Engineering has reviewed the plans for the Woodlands Landing at Echo Farms-Tract 3A project submitted February 1, 2019 and have the following comments:

WOODLANDS LANDING AT ECHO FARMS - TRACT 3A

DESIGN DOCUMENTS

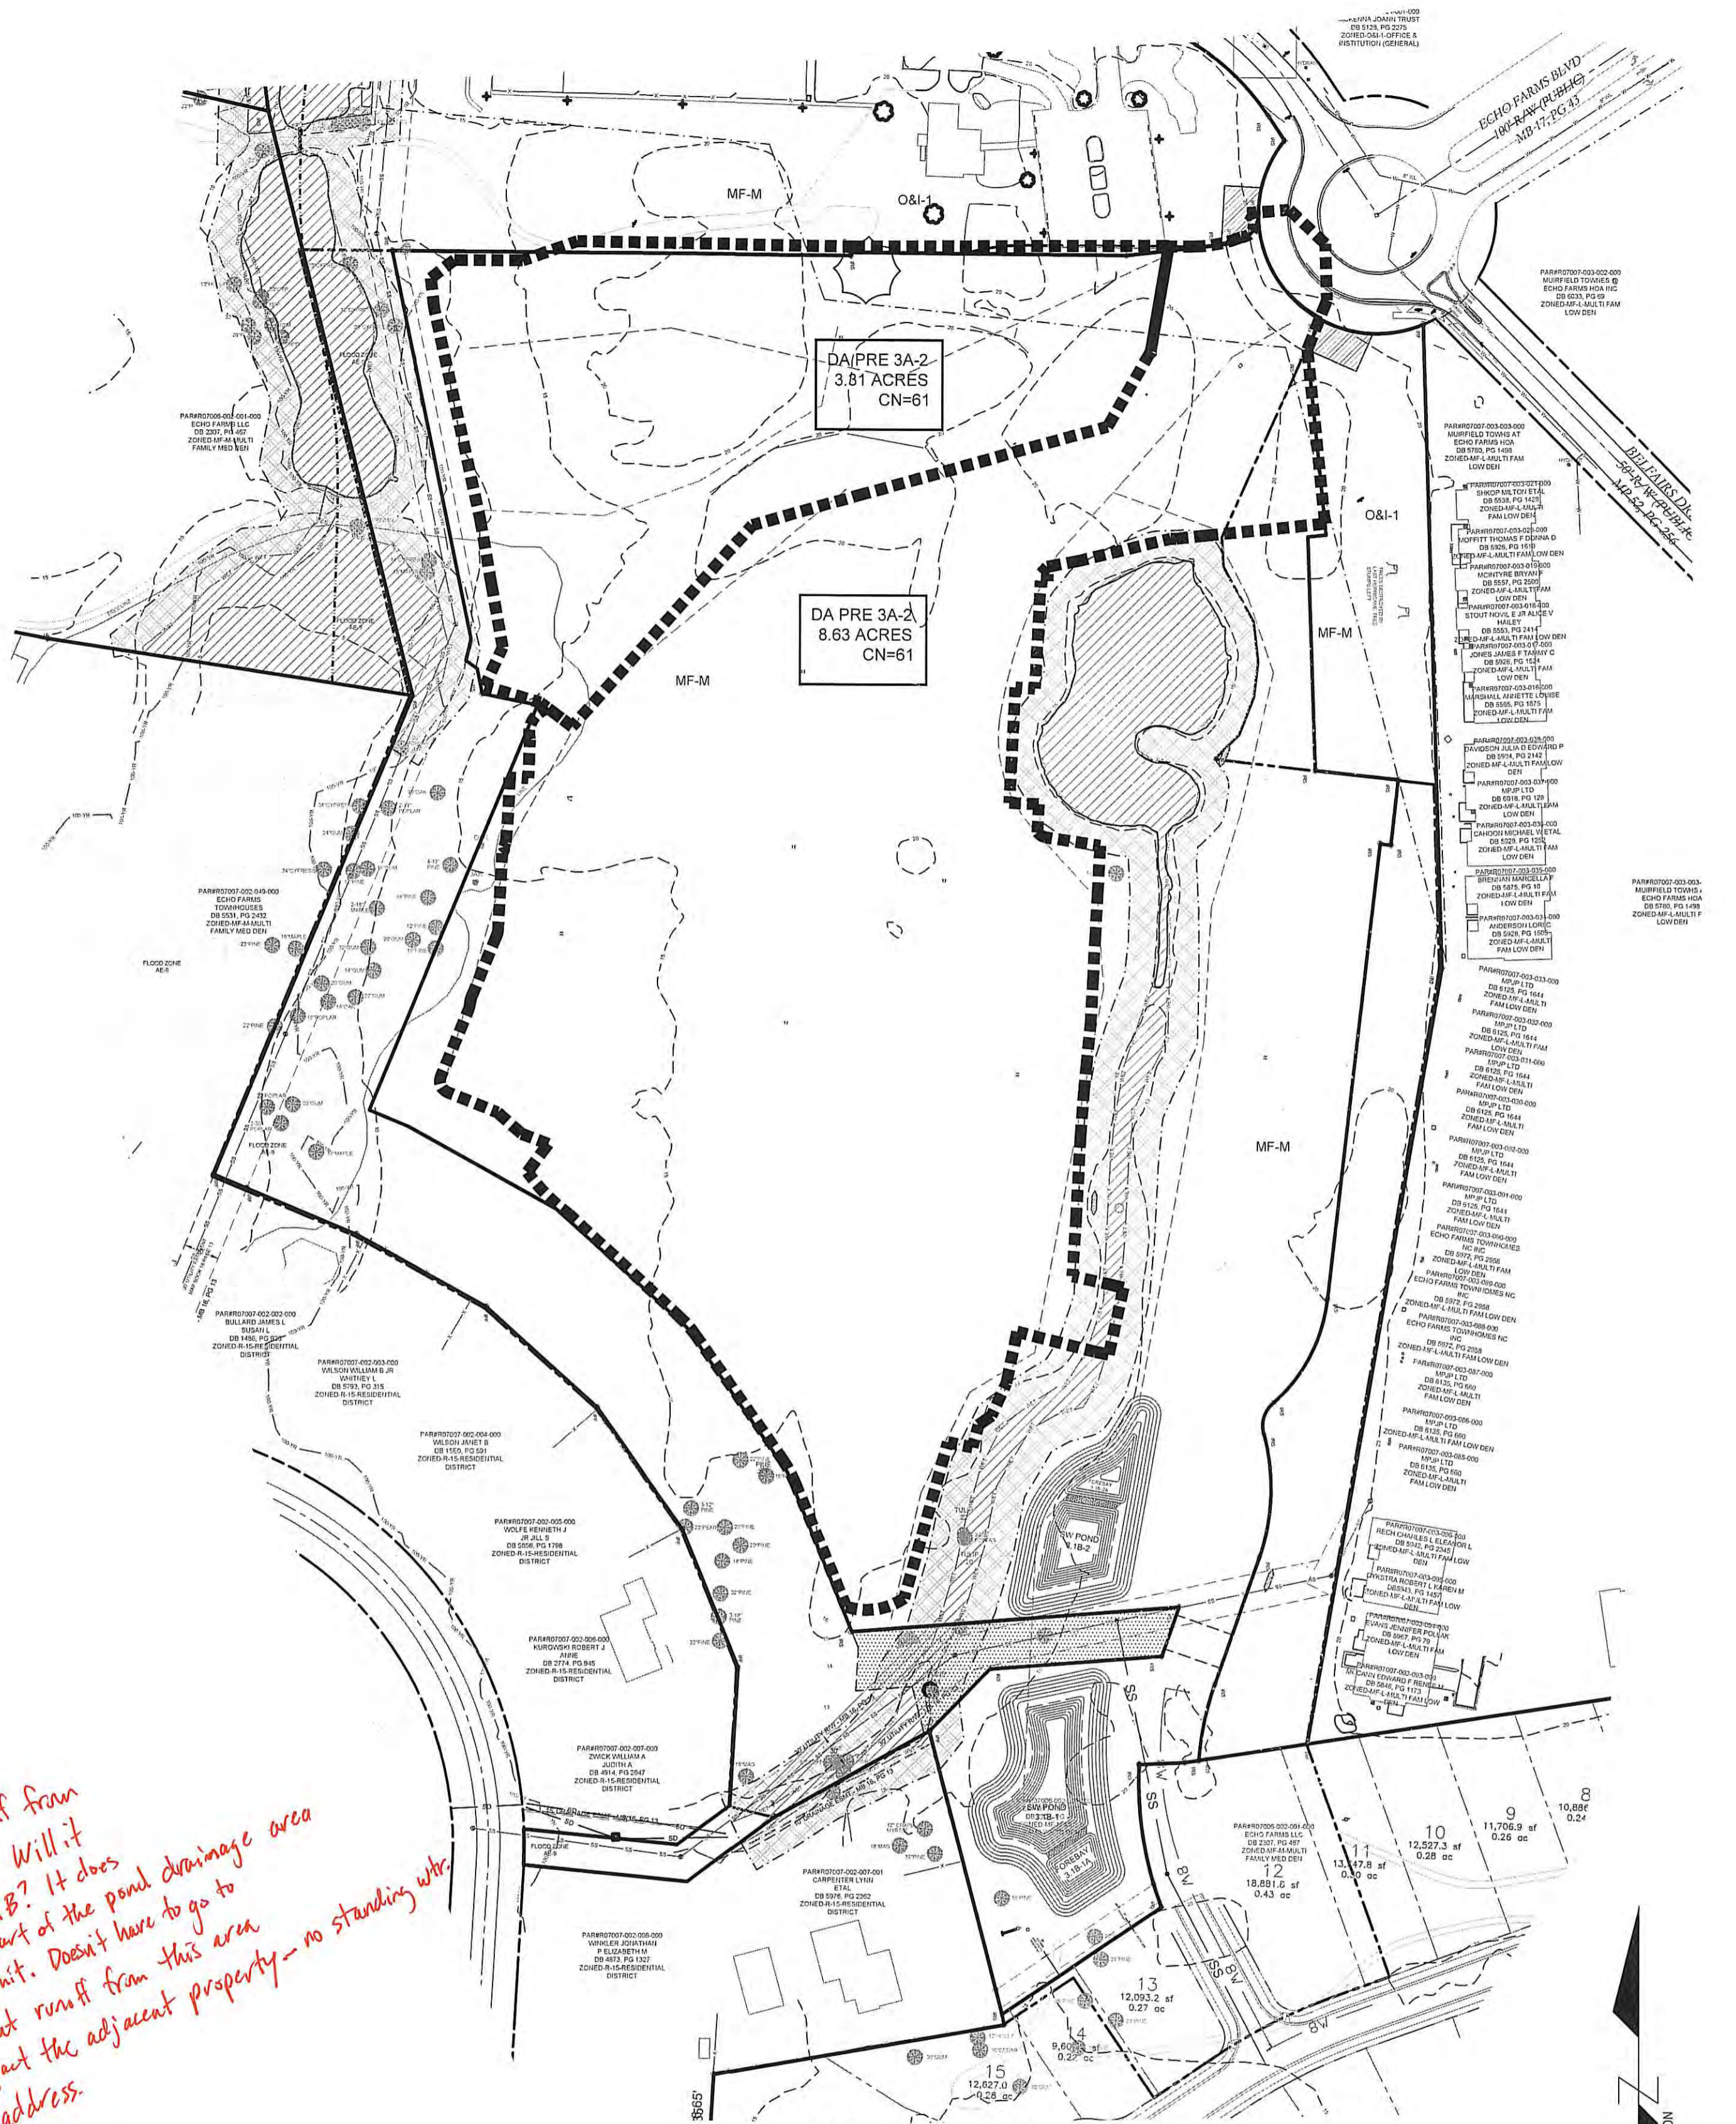
where does runoff from this area go? Will it enter pond 3-1B? It does show to be part of the pond drainage area in the 3B SW permit. Doesn't have to go to the pond but runoff from this area cannot impact the adjacent property - no standing water. Please address.

C-4.2

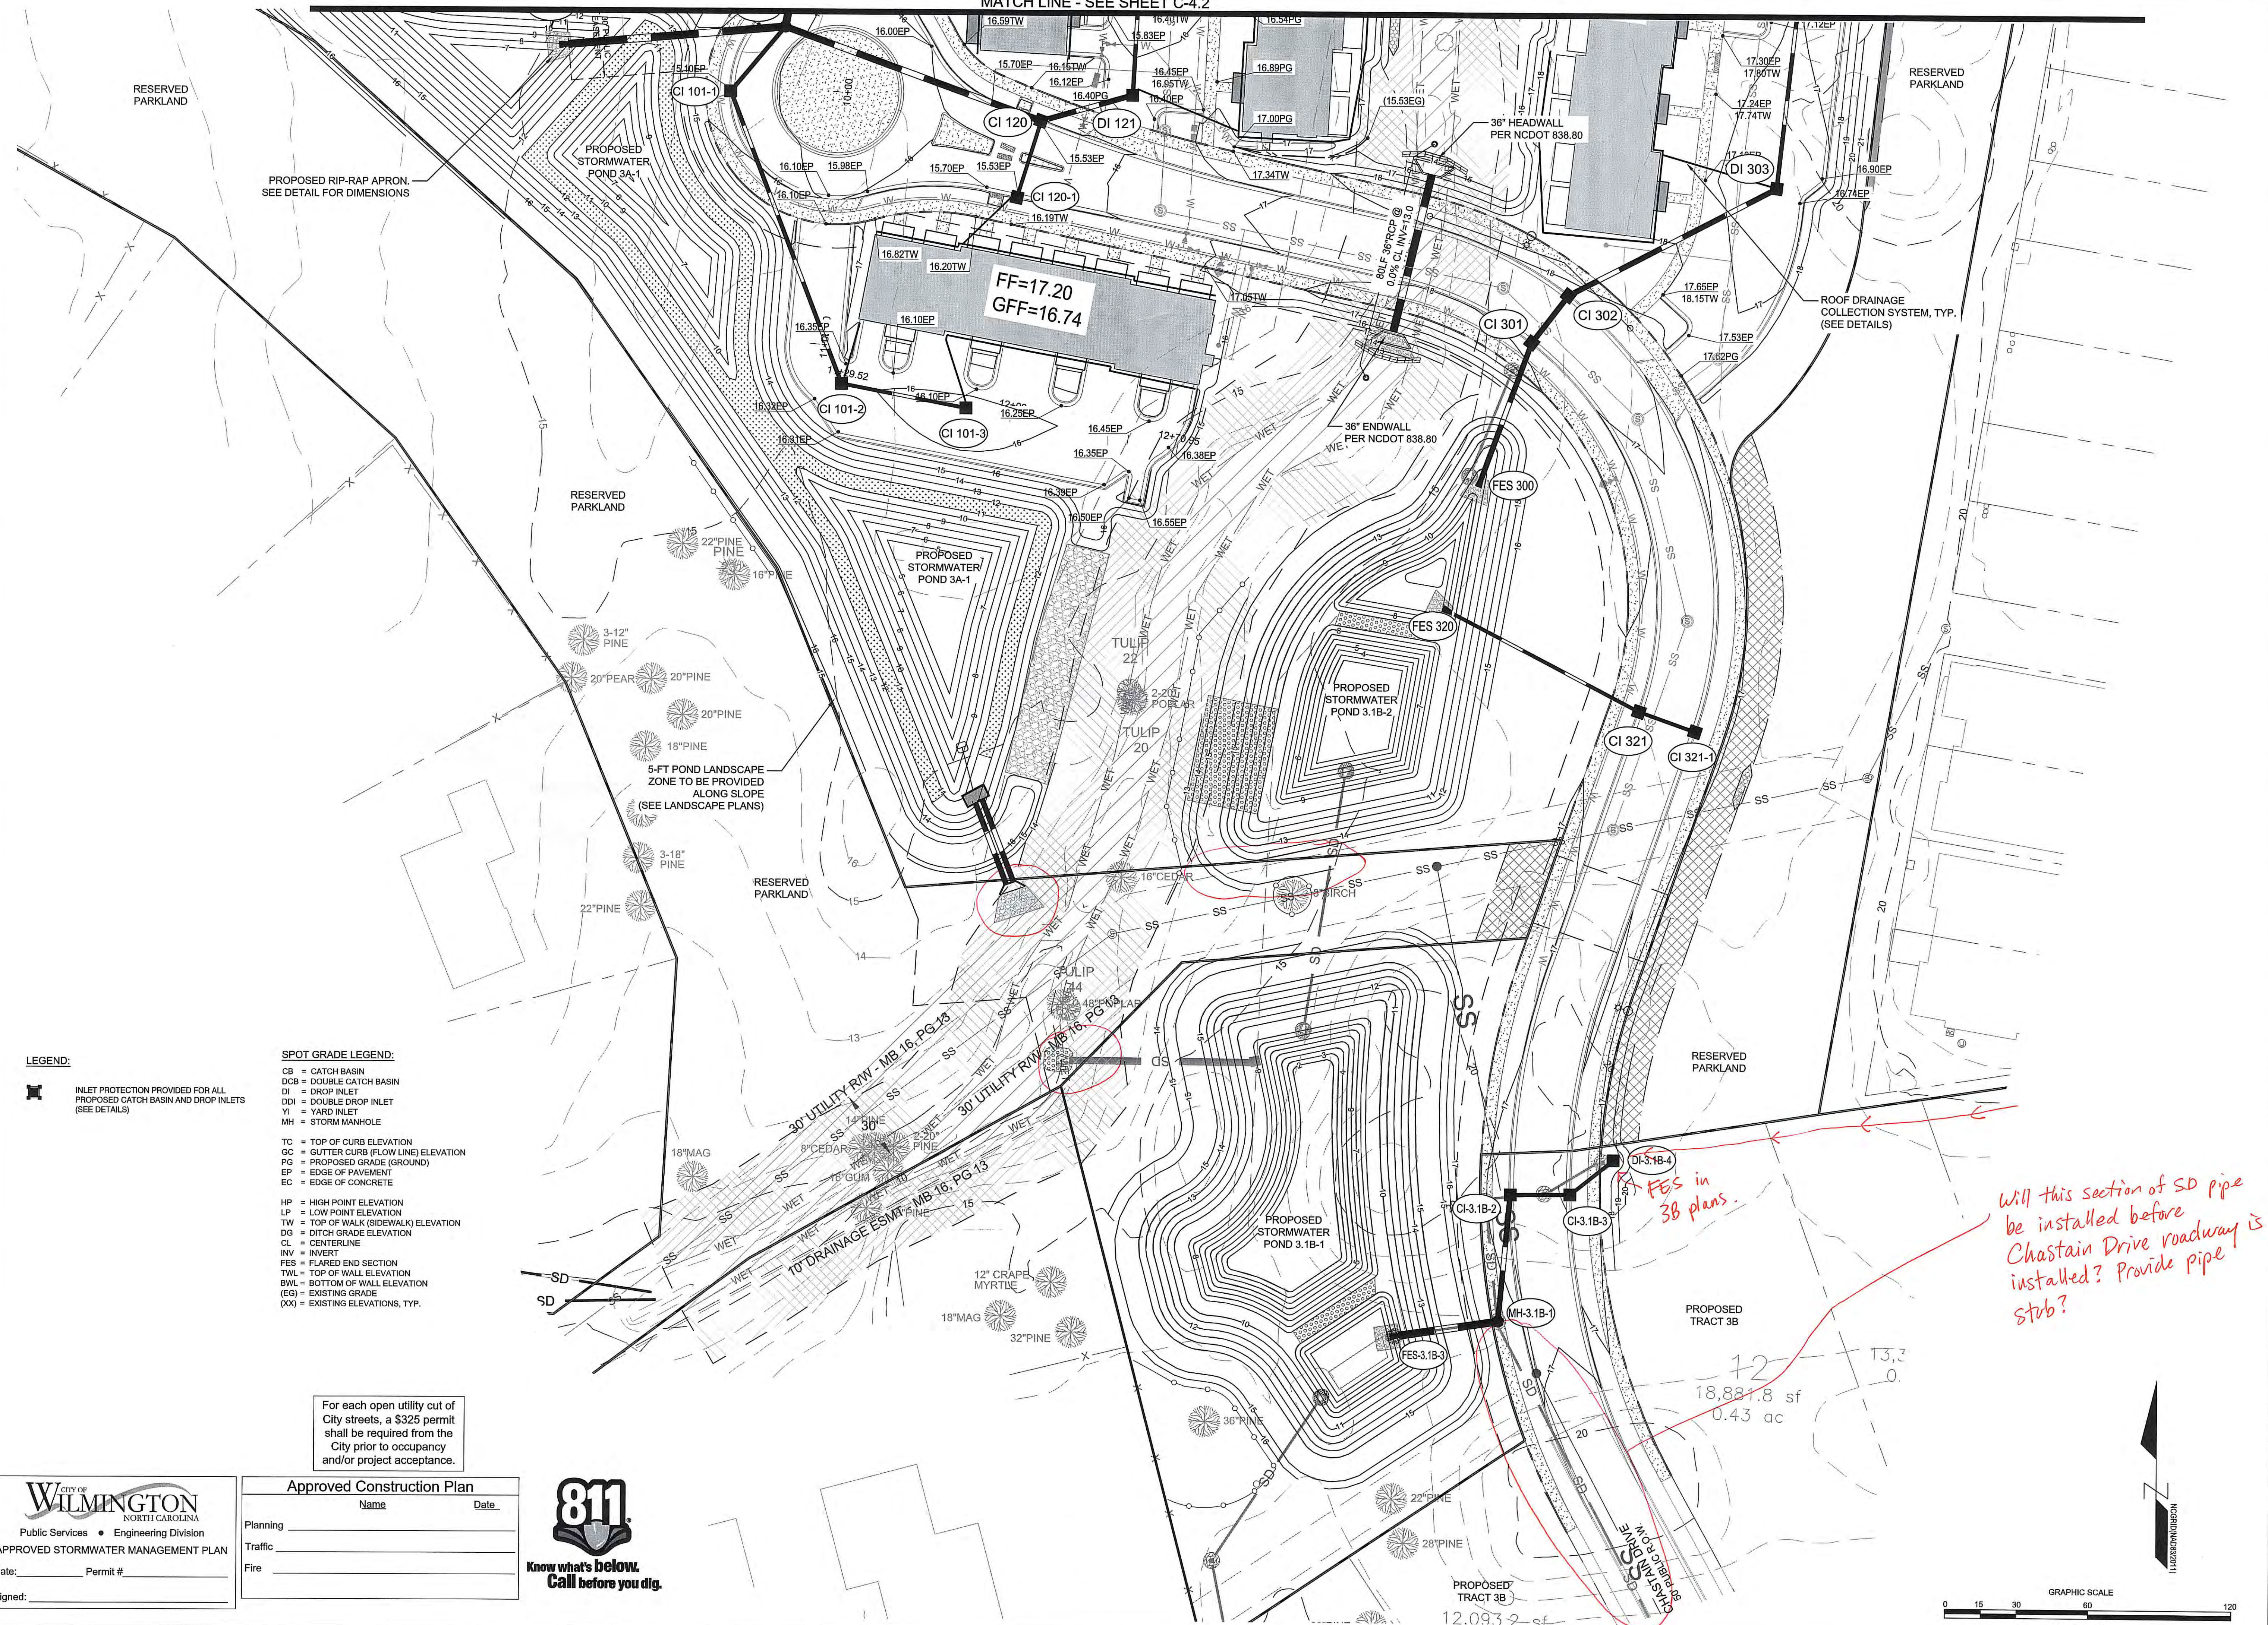
Will this section of SD pipe be installed before Chastain Drive roadway is installed? Provide pipe stub?

FES in 3B plans.
